SUBJECT: Northgate Shopping Center

### **Narrative Description of Proposed Alterations for Comprehensive Design Review (revised to reflect recommendations by UDC and city staff)**

#### **Revisions to previous submittal:**

**EXHIBIT 'A'**  
PROVIDED BY CITY OF MADISON,  
TRAFFIC ENGINEERING DIVISION

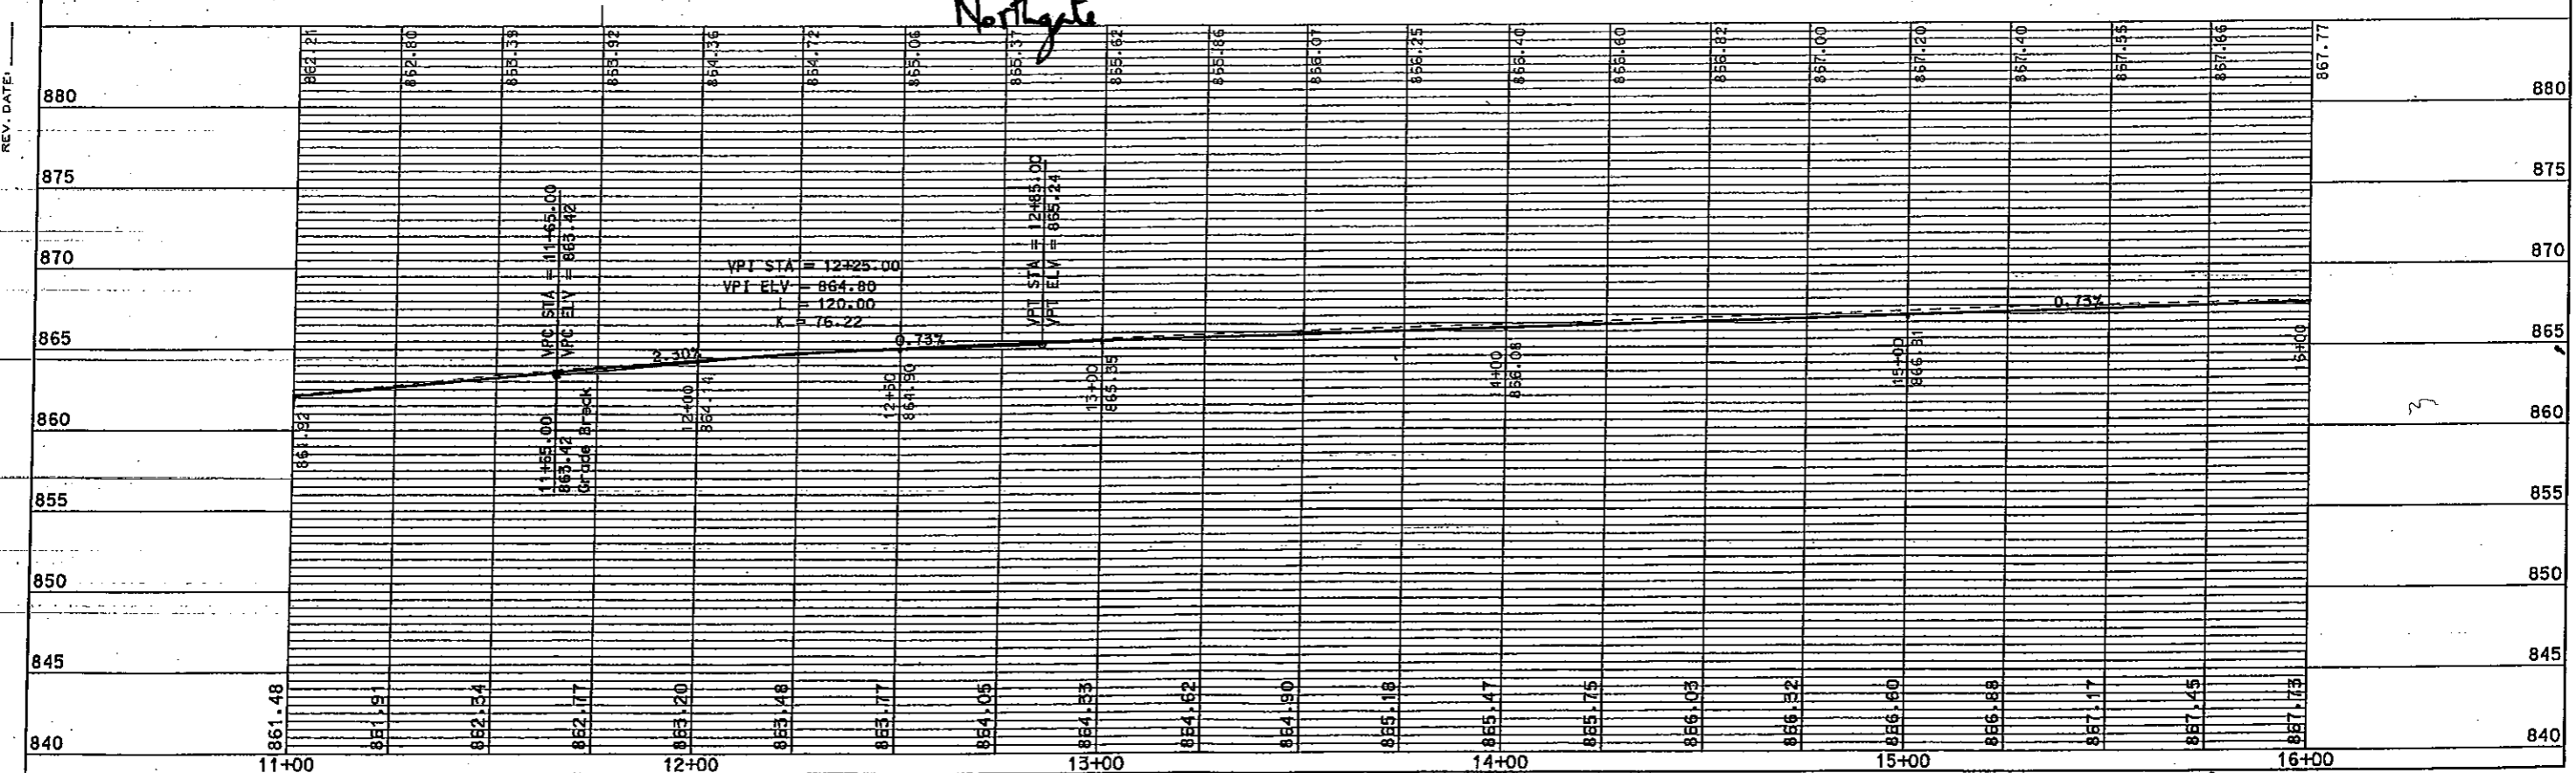
2. Additional landscape islands are included in the "future development zone". These islands will contain eight additional trees on the site.
3. The parking geometry has been modified to accommodate proposed changes to North Sherman Avenue made by the Traffic Engineering Division. In the future, new turn lanes, a pedestrian crosswalk and an island for pedestrian refuge will be constructed at the south entrance to the site. This proposal will require the Owner to relinquish 10' x 300' of right-of-way along North Sherman Avenue. Consequently, the location of the new monument sign must move north of current pylon sign. Refer to exhibit 'A'.

**'CONCEPT B'  
AERIAL OVERLAY SITE  
PLAN**

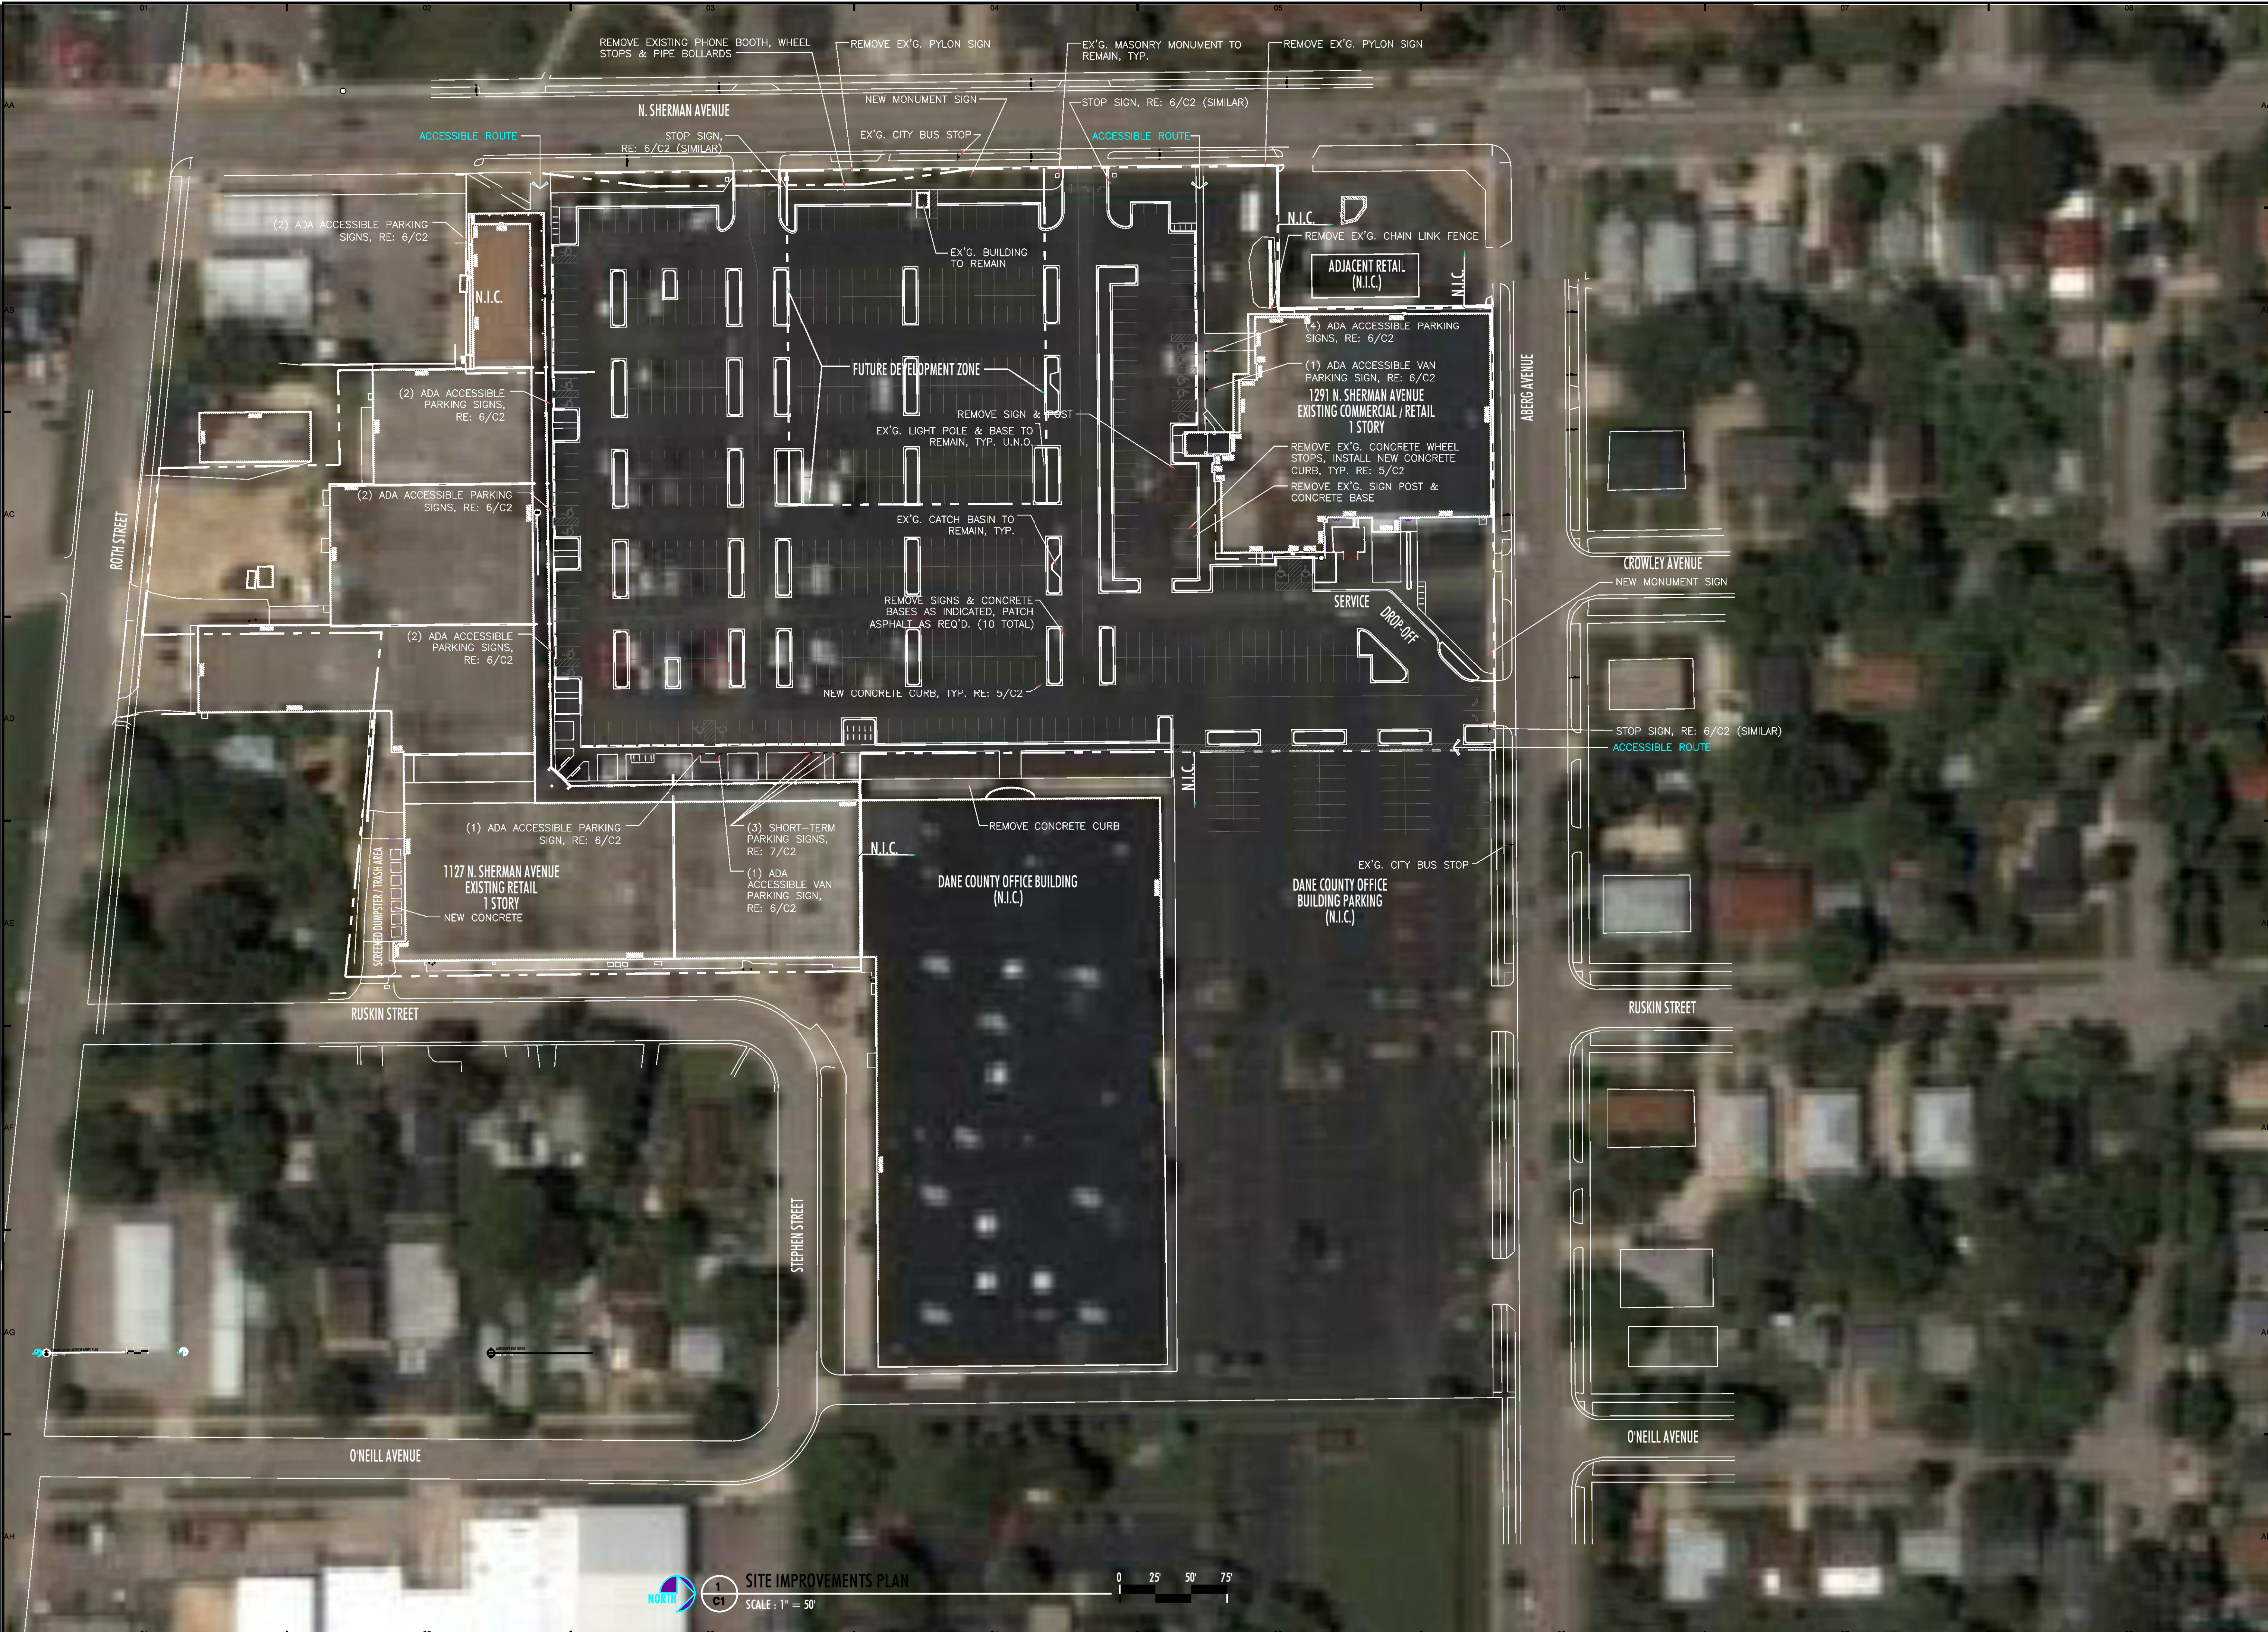
1. Site plan alternative 'B', showing relocated parking entry curb cut on Aberg Avenue, is the accepted version. The Developer will work with the Traffic Engineering Division to coordinate new entry with proposed traffic calming features on Aberg Avenue.
